Rezoning Transportation Analysis

Petition Number: 2025-131

Date	Description
1-22-26	First Review (BH)
2-19-26	Second Review (BH)
3-26-26	Third Review (BH)
4-23-26	Fourth Review (BH)

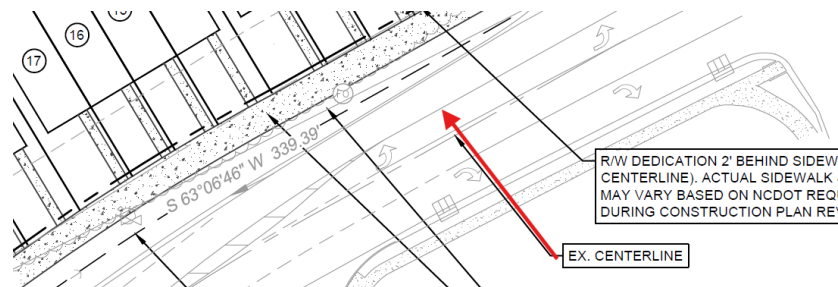
- a. ~~Grier/Rocky River Road: Future back of curb and gutter is to be located 30 feet from road centerline and must be shown in the future location according to UDO Article 32.7 and Charlotte Streets Map.~~

~~Arterial 4+ Avenue with Shared Use Path (Charlotte Streets Map).~~

~~Label and dimension the existing and future back of curb and gutter from the centerline for each road on the site plan.~~

~~**CLARIFYING COMMENT 2-19-26:** Revise callout/leader of "EX. CENTERLINE" to show existing striped center dividing line and show 2 westbound through lanes along project frontage.~~

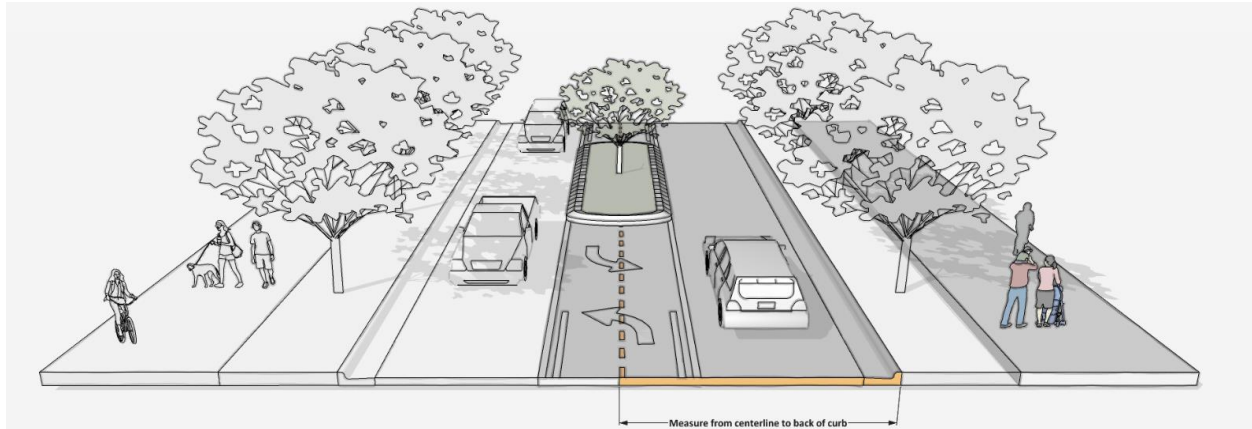
- b. ~~Rocky River Road: Future back of curb and gutter is to be located 19 feet from road centerline and must be shown in the future location according to UDO Article 32.7 and Charlotte Streets Map.~~

~~2+ Avenue, Shared Use Path~~

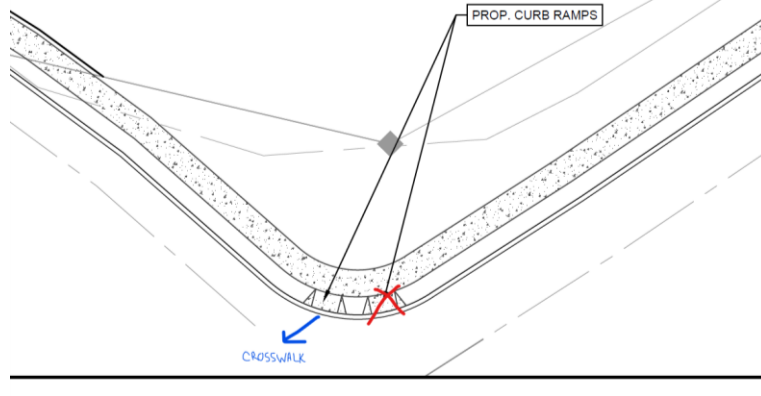
5. ~~**OUTSTANDING CDOT REQUEST FROM 01-22-26:** Revise site plan and conditional note(s) to commit to provide pedestrian facilities by constructing shared use path (SUP) connecting to existing crosswalk at Grier Rd and Rocky River Rd per CDOT request. Install a curb ramp matching the pedestrian paths width. This will complete a pedestrian network and create safe access to associated amenities in the area including Reedy Creek Park across the street.~~

CLARIFYING COMMENT 4-23-26: Revise site plan and conditional note(s) to commit to providing pedestrian connection to the existing crosswalk at Grier Rd / Rocky River Rd. Show one curb ramp and crosswalk connection to existing crosswalk. A pedestrian signal will be required to be installed. Screen in pedestrian refuge and a conditional note committing to finalizing pedestrian accommodations during permitting with CDOT.

CDOT REQUEST: In association with the required pedestrian signal, it is requested that the petitioner coordinate, where possible, the upgrade of existing pedestrian signals to meet current standards at the intersection. If the petitioner is agreeable to this, please add a conditional note committing to this improvement. Please reach out to Brent.Hyatt@Charlottenc.gov to discuss further.

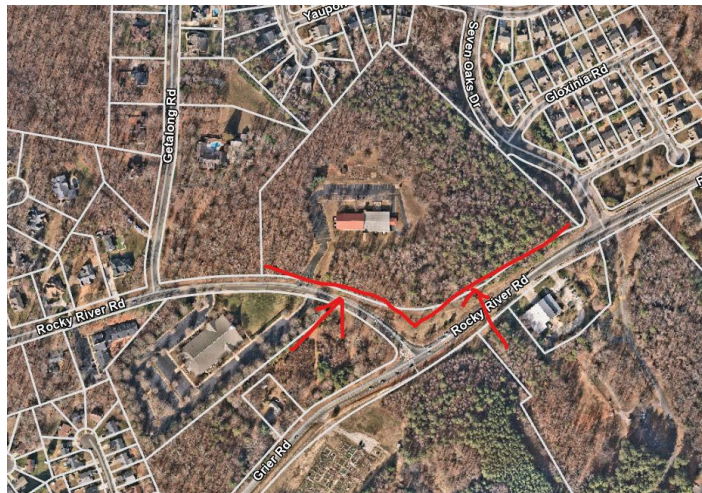
NEW COMMENT 3-26-26: This petition has been reviewed per subdivision requirements, and it was determined that street improvements are required along the entire frontage of the parcel in accordance with UDO Article 32.7. An 8-foot planting strip and a 12-foot Shared use path is required along the entire Grier Road and Rocky River Road frontages, not just the development area. Include ramps at the corner of Grier and Rocky River. Curb and gutter is required to be constructed per Charlotte Streets Map. See comment 1 for curblines locations for both frontages. Show these improvement on the site plan along with callouts and dimensions from the roadway centerline. Add conditional notes to commit to installing these improvements. CDOT is scheduling a meeting with NCDOT to discuss the curblines requirements. Please reach out to Brent.Hyatt@charlottenc.gov to confirm curb line requirements per NCDOT discussion.

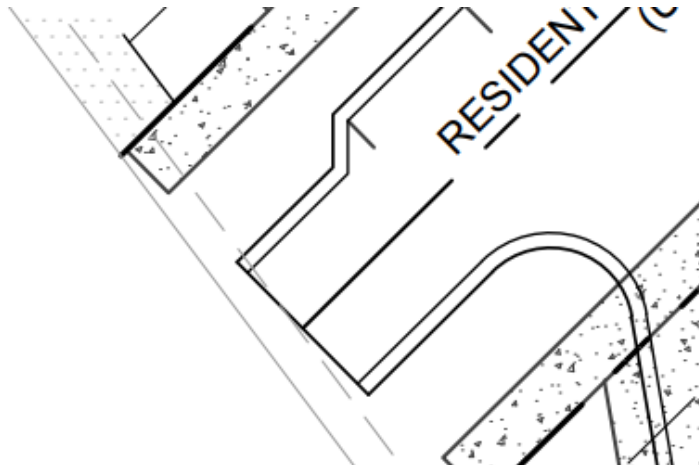
6. ~~OUTSTANDING COMMENT FROM 1-22-26:~~ Revise site plan and conditional note(s) to clearly show/label internal alleys as private. Identify them as either a private street or private alley. Add a conditional note identifying each.

7. Revise site plan and conditional notes to commit to providing internal public road as Local Residential Wide Street with 8' planting strip and 8' sidewalk. Label and dimension the future back-of-curb and gutter from the centerline of the proposed road.

~~CLARIFYING COMMENT 2-19-26:~~ Label and dimension the future back of curb and gutter from the centerline of the road on the site plan.

8. ~~OUTSTANDING COMMENT FROM 1-22-26:~~ Revise site plan and conditional note(s) to clarify how the proposed internal public road is to be terminated, whether a stub for future extension or a cul de sac for permanent dead end. Coordinate with subdivision to verify requirement.

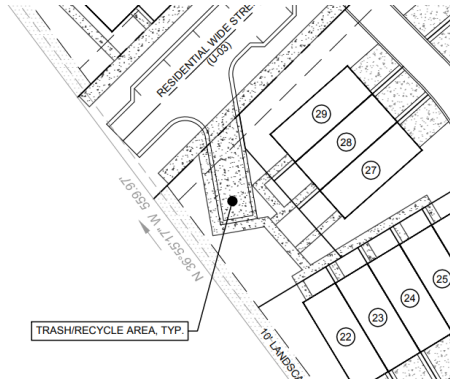
9. **OUTSTANDING COMMENT FROM 1-22-26:** ~~Revise site plan and conditional note(s) to provide labels and dimensions for driveway spacing and angle of intersection for proposed “trash/recycle area.” The angle of a driveway intersection with the public or network required private street shall be 90 degrees in accordance with UDO Article 31.3.~~

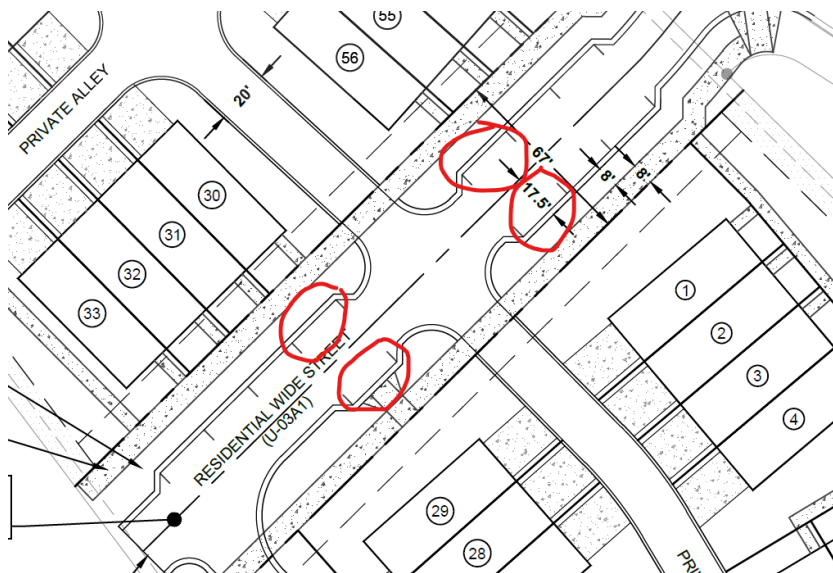
10. **OUTSTANDING COMMENT FROM 1-22-26:** Revise site plan and conditional note(s) to show that on-street parking must meet City standards, and ADA/PROWAG guidelines. Show proper spacing from driveways and curb ramps etc...One of the on street parking spaces are to be designed as an ADA stall.

CLARIFYING COMMENT 4-23-26: Remove proposed on-street parking spaces to ensure that the minimum required spacing is met per CLDSM.
